STONEBRIAR ADDITION

WICHITA, SEDGWICK COUNTY, KANSAS

Re: S/D 96-32 STONEBRIAR ADDITION (One Step Preliminary-Final Plat)

Re: S/D 96-32 STONEBRIAR ADDITION (One Step Preliminary-Final Plat)

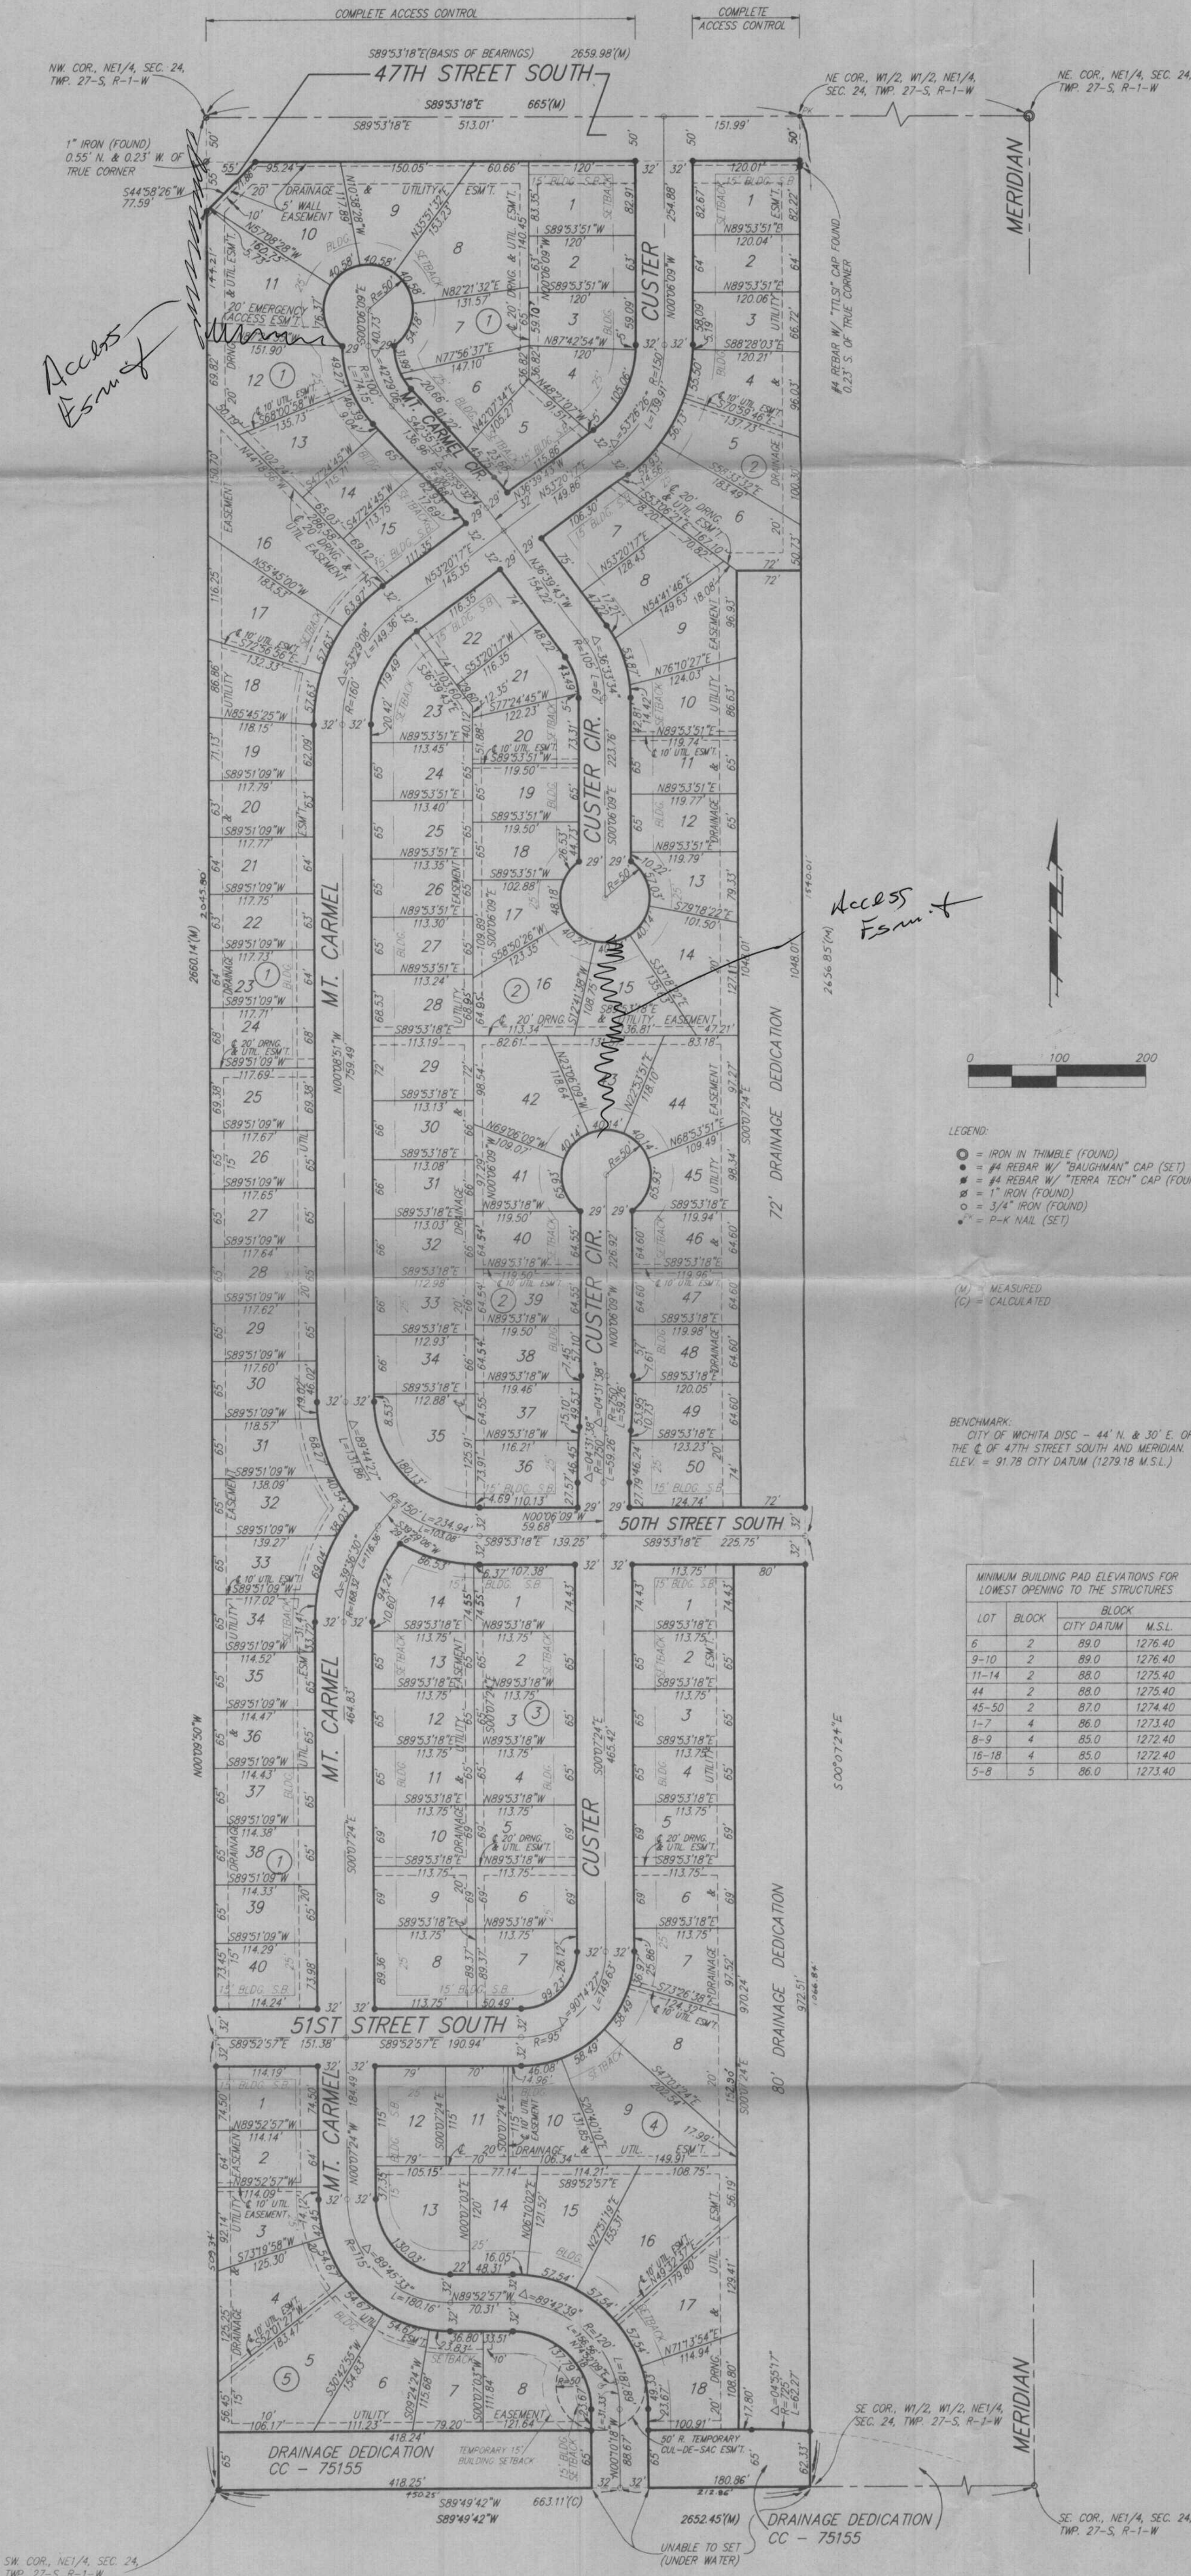
- ☒ A. The applicant shall guarantee the extension of sanitary sewer to serve the lots being platted. This guarantee shall also include any needed off-site extensions.

- ☒ B. The applicant shall guarantee the extension of City water to serve the lots being platted. This guarantee shall also include any needed off-site extensions.

- ☒ C. The applicant shall guarantee any drainage improvements required by the platting of this property.
- ☒ D. The applicant shall guarantee construction of the storm sewers required by this plat.

- ☒ E. The applicant shall guarantee the paving of the proposed interior streets. This guarantee shall include sidewalk along one side of all non-cul-de-sac'd streets, including any street stub sections and streets ending in a permanent or temporary turnaround. Also, this guarantee shall provide for a temporary or permanent turnaround at the site's southern line (for Custer). However, Custer's right-of-way shall in any case, extend to the south line of this plat.

- ☒ F. If determined appropriate by Planning and Traffic Engineering, the applicant shall guarantee accel/decel and/or left-turn lanes to serve this site's one point of entry at 47th Street South. The applicant shall meet with Staff to determine if this improvement will be needed.

- ☒ G. The applicant shall submit a guarantee to participate in any needed reconstruction (paving) of 47th Street South adjacent to this site.

- ~~I.~~ On the final plat tracing, complete access control shall be dedicated to 47th street South from the adjacent lots.
- (J.) Prior to submitting the final plat tracing, the applicant shall meet with City Engineering to determine if a drainage dedication will be accepted or if the involved area needs to be platted as a Reserve. As requested by City Engineering, additional information needs to be provided in regard to the cross section of the drainage way and the available areas either side for access and maintenance of any such dedication. If the area is platted as a Reserve, this plat will be subject to the standard requirements for such Reserve areas. If a dedication is accepted, the plat shall also note that this area is available for public use as a recreational bike and hike, etc. area.

- ~~K.~~ *see note on improvement unit. sheet submitted by appli*
The applicant shall either provide a covenant restricting development of lots south of 50th Street South until another means of acceptable access is provided to this site (public street extended to this plat's indicated street stubs) or an acceptable area is provided for an emergency access easement and a guarantee submitted to install an appropriate all-weather driving surface. The applicant is encouraged to consider such an easement in conjunction with the above noted drainage dedication/Reserve.

- (L.) Based on the platting binder, a blanket pipeline easement apparently covers this site. Prior to this plat being released for recording, the applicant shall provide proof that this easement has been released. If confined, and located any where on this site, this plat will be subject to the standard requirements concerning pipelines and pipeline easements.

- ~~M.~~ The preliminary plat is presently indicating 3 of the plat's 4-corners as being tied to the N.W. corner of this quarter section. On the final plat tracing, any such corner references shall note a proper corner (NE, SE, etc.).

- Q. Perimeter closure computations shall be submitted with the final plat tracing. Section 5-101(c).
- R. Recording of the plat within 30 days after approval by the City Council.

- T. The final plat shall indicate the utility easements requested by K.G.& E. and Southwestern Bell which are indicated on the enclosed "marked" copy of the plat. The applicant is also encouraged to discuss with the utilities (KG&E and S.W. Bell) the appropriateness of platting 20-foot, combined drainage and utility easements for this site. If necessary, the final plat shall revise such easements (increase their widths, drop drainage use, etc.)
